ADDENDUM NUMBER TWO
Thursday, December 4, 2014

PROJECT: USC UPSTATE COLLEGE OF ARTS AND SCIENCES STRUCTURAL REPAIRS
UNIVERSITY OF SOUTH CAROLINA UPSTATE
STATE PROJECT NO. H34-I367
BaSE, Inc. PROJECT NO. 14105

SECTION @ GUARDRAIL

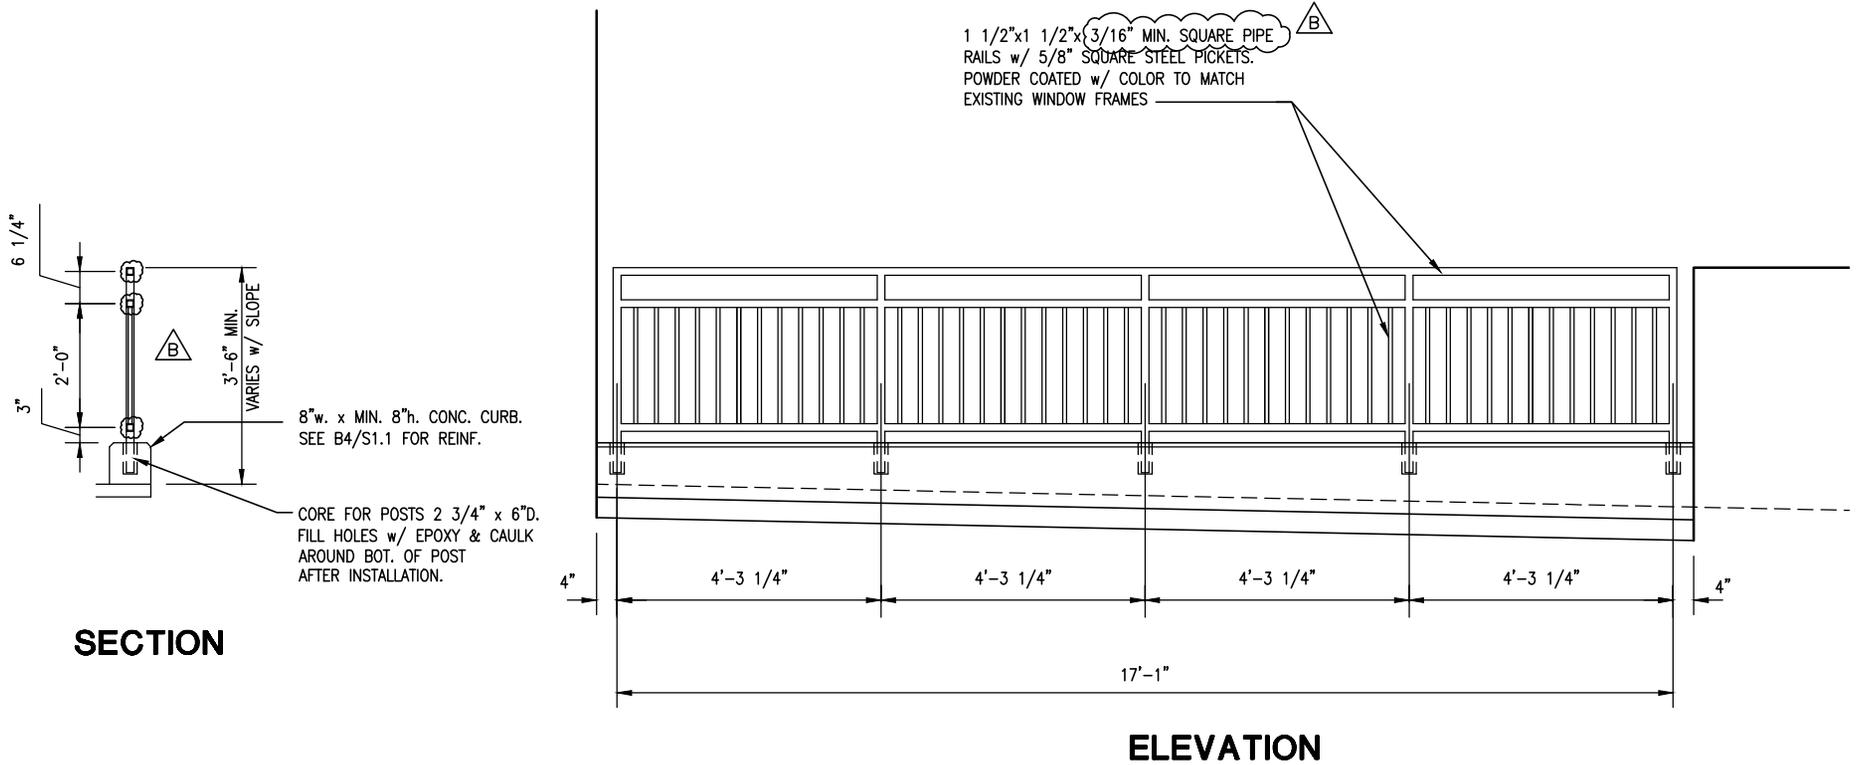
2. QUESTION: The Detail C1/S1.1 notes that square members are to be used on the new handrail. Round members are shown on the accompanying section on Detail C1/S1.1 as well as the Detail B4/S1.1. Which member shape is required?

ANSWER: Use 1-1/2" x 1-1/2" square pipe railing for the three horizontal members and the vertical posts. Use 5/8" square vertical pickets. See the attached Detail C1/S1.1 and B4/S1.1.
